Well Name: BIG EDDY UNIT DI 30 WEST 15-20	Well Location: T20S / R31E / SEC 15 / SESE / 32.567897 / -103.848939	County or Parish/State: EDDY / NM
Well Number: 7H	Type of Well: OIL WELL	Allottee or Tribe Name:
Lease Number: NMLC065944A	Unit or CA Name: BIG EDDY	Unit or CA Number: NMNM68294X
US Well Number:	Operator: XTO PERMIAN OPERATING LLC

Type of Action: APD Change

Procedure Description: APD ID# 10400097401 XTO Permian Operating, LLC. respectfully requests approval to make the below listed changes to the approved APD – 1. Casing design to be changed from a 4-string engineered weak point design to a 4-string design with an uncemented annulus between 2nd intermediate and production casing strings 2. Associated changes required in the cement program & the mud circulation system as per the newly proposed casing design No changes requested to the SHL/BHL/take points, proposed MD/TVD and formation (pool). There will be no new surface disturbance. See attached drilling program for the updated casing design, cement program & mud circulation system. Attachments: Drilling Program, Non-API Spec document for Production Casing, Well bore diagram, Diverter Diagram, Flex Hose Variance, Spudder

[Figure E] 4 String – Uncemented Annulus between 2nd Intermediate and Production Casing Strings. (Reference R-111-Q: Exhibit B)

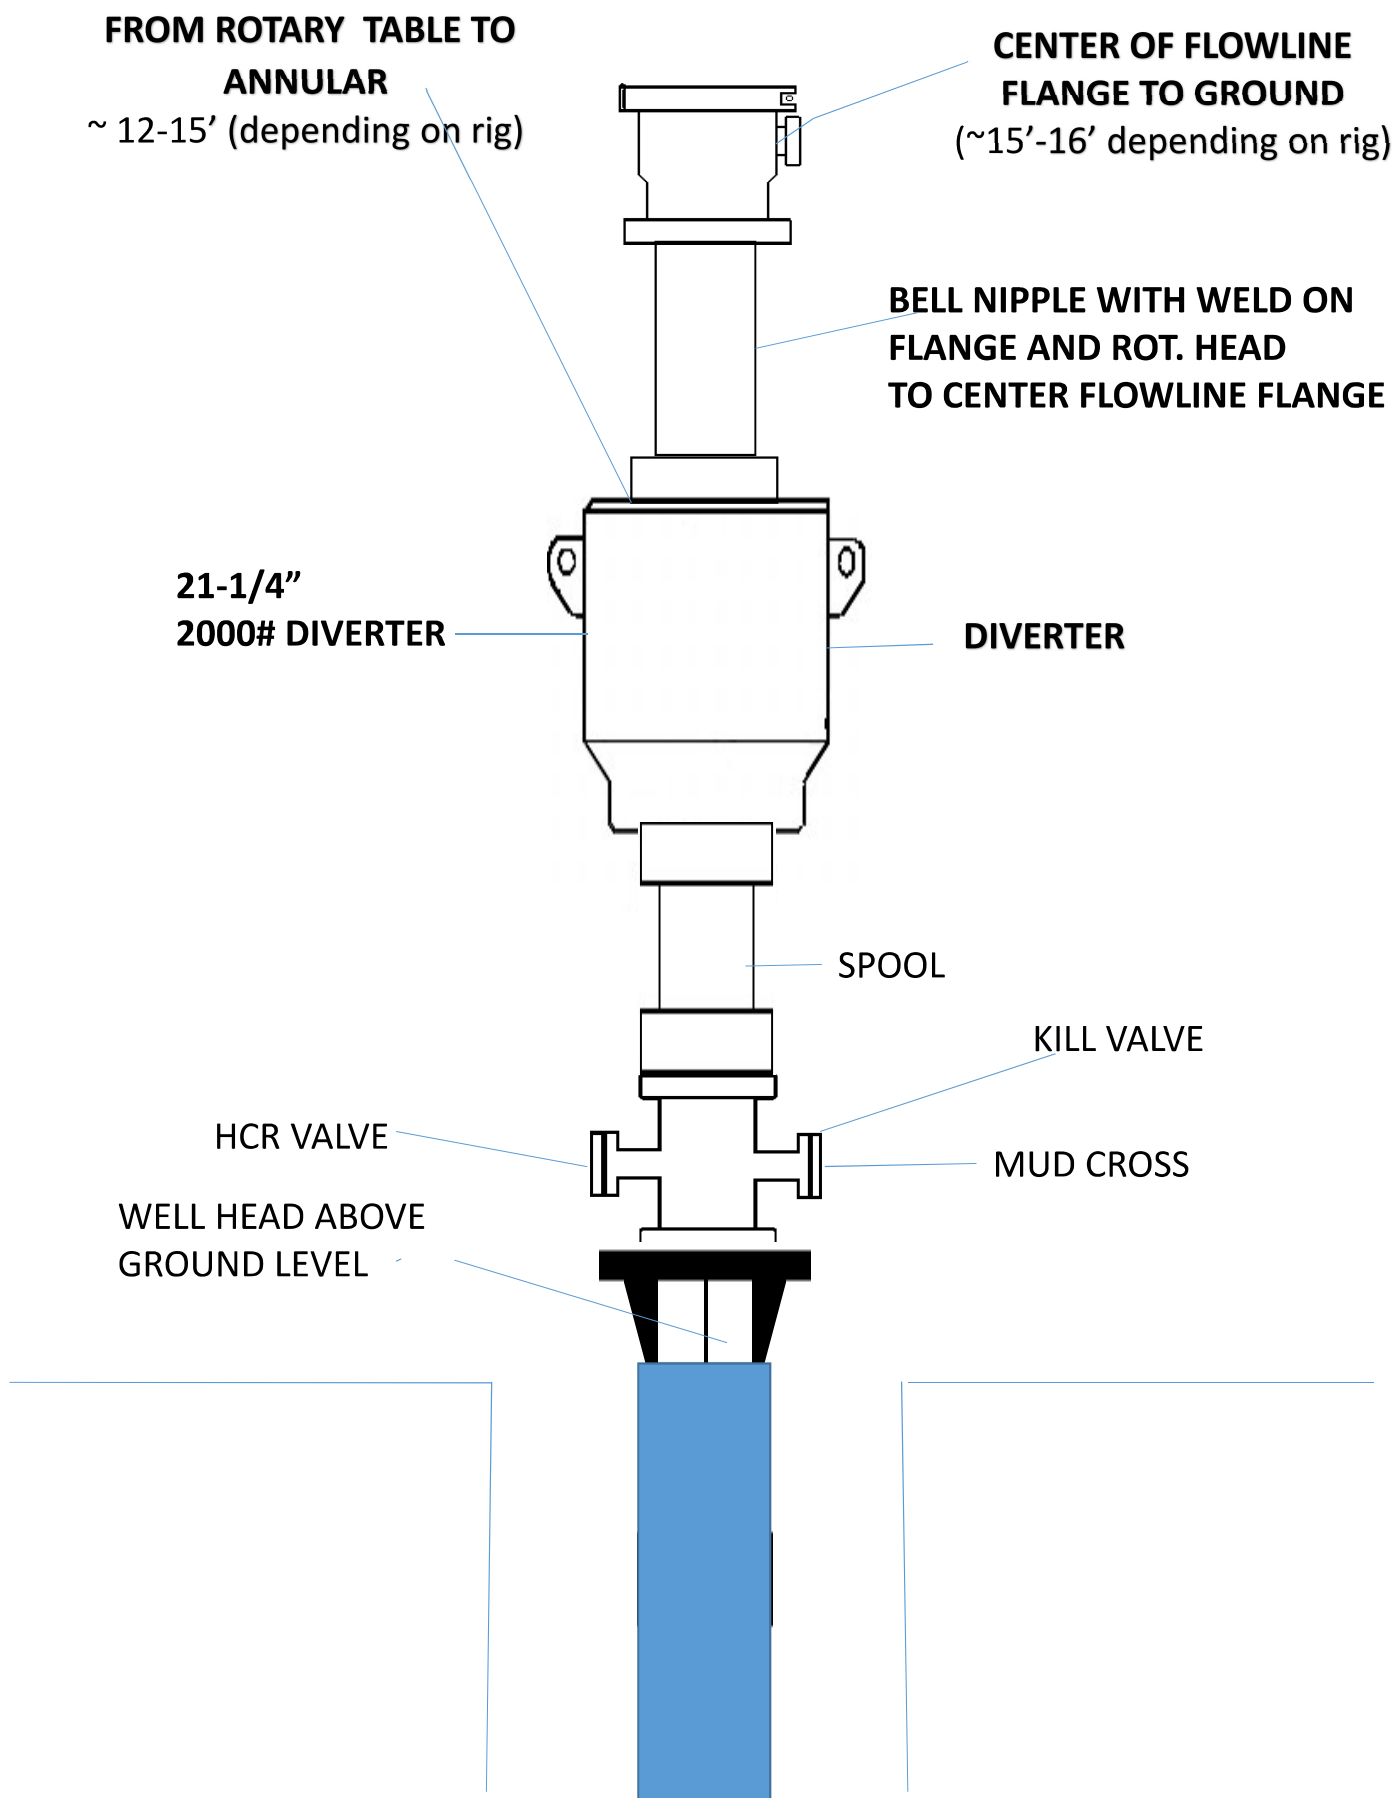
1. Casing design to be changed from a 4-string engineered weak point design to a 4-string design with an uncemented annulus between 2nd intermediate and production casing strings

2. Associated changes required in the cement program & the mud circulation system as per the newly proposed casing design

Open 2nd intermediate x production annulus to monitor during completion. In the event of production casing failure, pressure will either release at surface or into the formation below 2nd intermediate shoe in the Delaware Mountain group / Brushy Canyon relief zone (R111Q Figure E)

- Alignment with KPLA requirements per schematic below, with open 2nd Int x production casing design and utilizing new casing that meets API standards.

- Production casing will consist of a primary cement job with TOC at the top of the Brushy Canyon formation within the Delaware Mountain Group with 0% excess and well below the minimum of 500' from Intermediate 2 casing shoe.

4. The minimum required fill of cement behind the 6 inch production casing is:
 - Cement should tie-back **500 feet** into the previous casing but not higher than **USGS Marker Bed No. 126. Operator must verify top of cement per R-111-Q requirements.** Submit results to the BLM. If cement does not circulate, contact the appropriate BLM office. **Wait on cement (WOC) time for a primary cement job is to include the lead cement slurry due to cave/karst, Capitan Reef, or potash.**
